DOCKET NO: 50-346

APPLICANT: Toledo Edison Company (TECO)

FACILITY: Davis Besse, Unit 1 (DB-1)

SUMMARY OF NRC SITE VISIT TO THE DAVIS BESSE NUCLEAR POWER STATION, UNIT 1

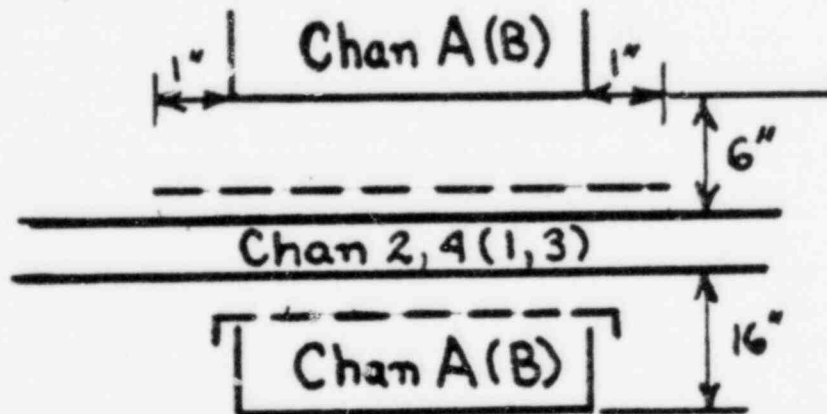
6. Cable tray cross sections as observed for DB-1 are shown in the following sketch.

The staff indicated that the cable tray design as indicated above was a good design.

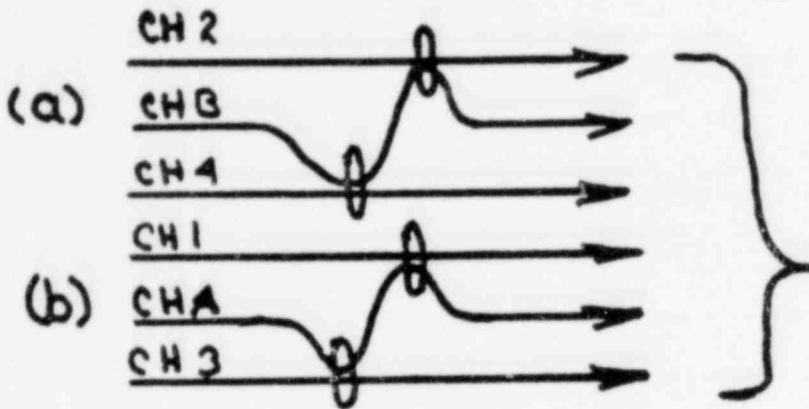
7. TECO stated that the minimum separation distance between redundant cable trays was 4 feet vertical and 18 inches horizontal (bottom to bottom). Less separation would require installation of a barrier. The staff indicated the above provisions were acceptable.
8. Non essential cable trays (Channels A, B, or C) are permitted between redundant essential cable trays. The staff concluded that this was acceptable provided the following minimum separations were maintained. Less separation would require fire barriers as shown by dotted lines.

TECO stated that the above criteria was acceptable to them.

Unacceptable

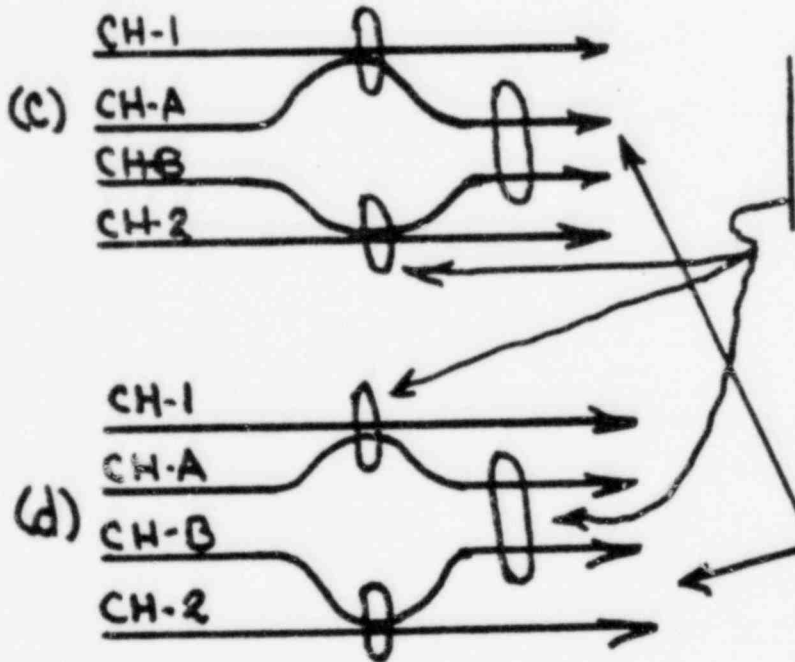
9. The applicant provided a draft of the separation criteria for cable routing inside enclosures, (Control boards, instrument cabinets, distribution panels, motor control centers, etc). The following diagrams reflect the staff positions regarding cable bundling.

Areas where cables are bundled together (with no separation or barriers provided)

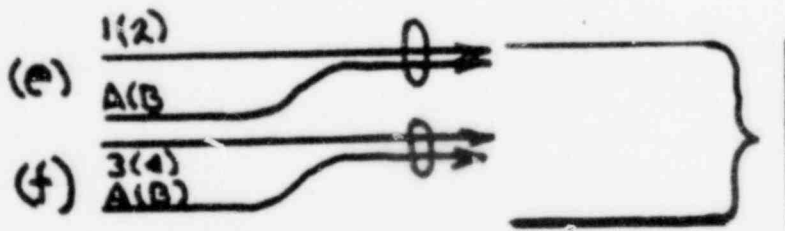
Unacceptable unless it can be demonstrated by test that flame propagation from one safety channel to a redundant safety channel will not occur for these configurations.

Acceptable provided verification that cable A(B) is not also bundled, routed, or formed with any cable at another essential channel.

Acceptable (Minimum 12 inches or barrier)

TECO stated that flame test data would be documented to substantiate the acceptability of arrangements 9-c) and 9-d) above.
